Proposal for 10 series of amendments to Regulation No. 17 (Strength of seat)

The text reproduced below was prepared by the expert from CLEPA aimed to amend the proposal of 10 series of amendments of document proposed by Japan and the European Commission in their proposal ECE/TRANS/WP.29/GRSP/2018/34. The modifications to the text of the UN Regulation are marked in bold for new or strikethrough for deleted characters.

Annex 10, paragraph 2.3., amend to read :

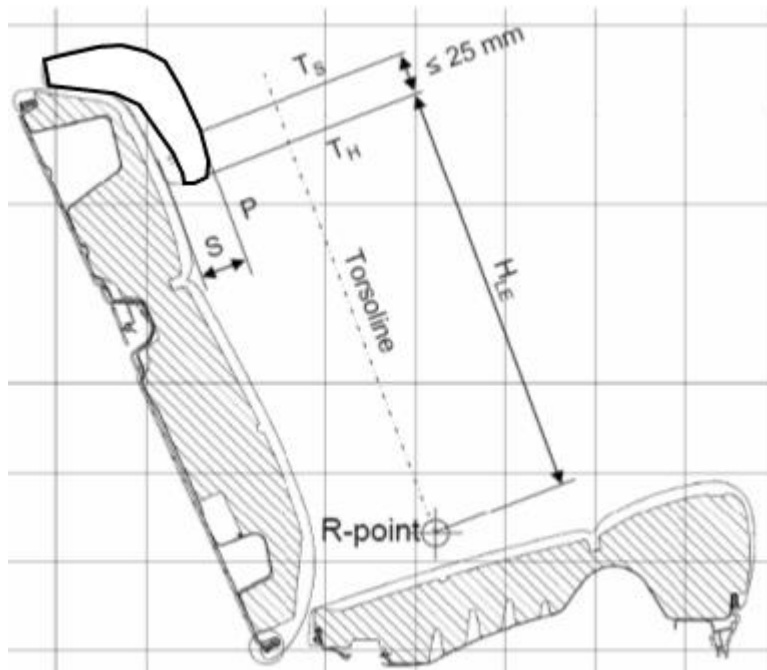
2.3. Height measurement

All measurements shall be taken in the median longitudinal plane of the ~~designated~~ seating position.
